LIGO PROJECTCALIFORNIA INSTITUTE OF TECHNOLOGY
PASADENA, CALIFORNIA 91125

Attached are changes recommended for positioning thermocouples on the QT module. Total quantity is still 20. Criteria which led to these changes are:

RECOMMENDED
CHANGES IN
THERMOCOUPLE
POSITIONS FOR QT
TOTAL = 20 T/C

SKETCH 2 - THERMOCOUPLE LOCATIONS

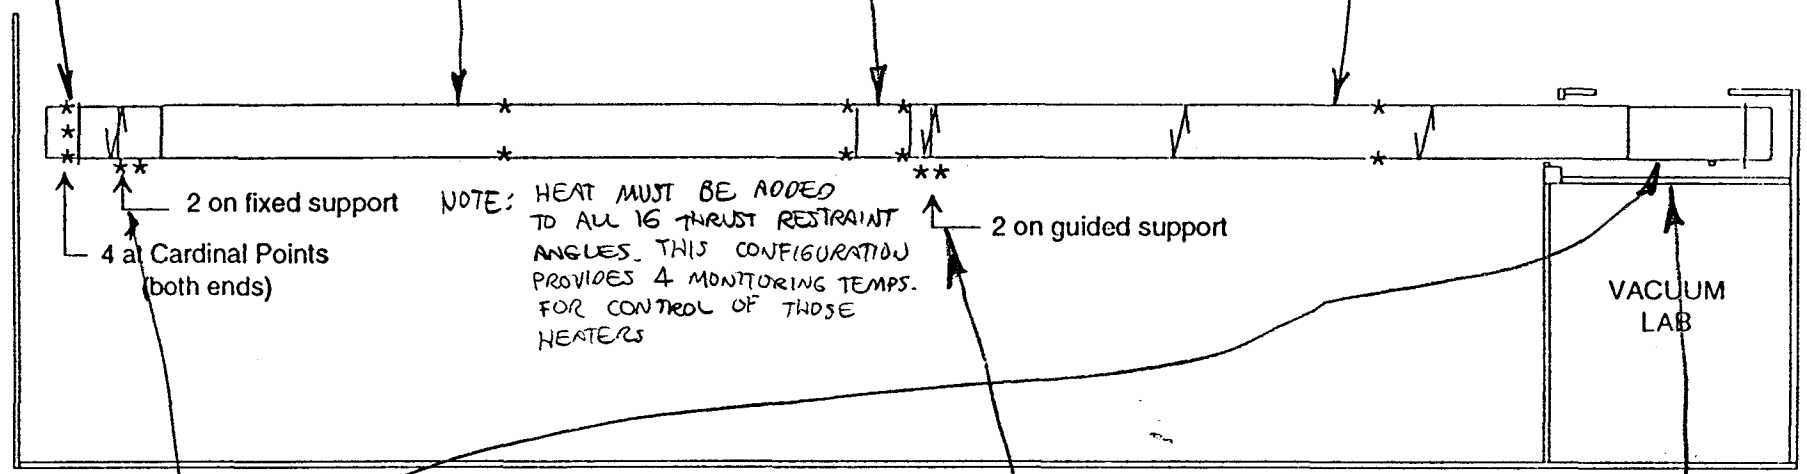
1. Two of the locations are typical for the length of the module: at the top and the bottom of the tube sections, at mid length, halfway between stiffening rings. One of these is a likely control sensor.

2. We're looking for cold spots; some of the positions are chosen to represent likely heat leak paths: near stiffening ring and support ring welds, at the center of the end caps, and near support connection points.

3. The bellows would get hotter than the tube with equal insulation, since it's thinner and has more electrical resistance. I've estimated that a single 2" thickness of insulation will give about the same temperature; CBI should check this. The two bellows T/C positions shown will give a check on insulation calcs.

4. The thrust restraints required for the QT are heat leaks, and will each (all 16) need heaters installed to minimize leakage. Two thrust restraints on each end are instrumented to properly control the heating, and the nearby tube wall is sensed to confirm that the effects are as desired.
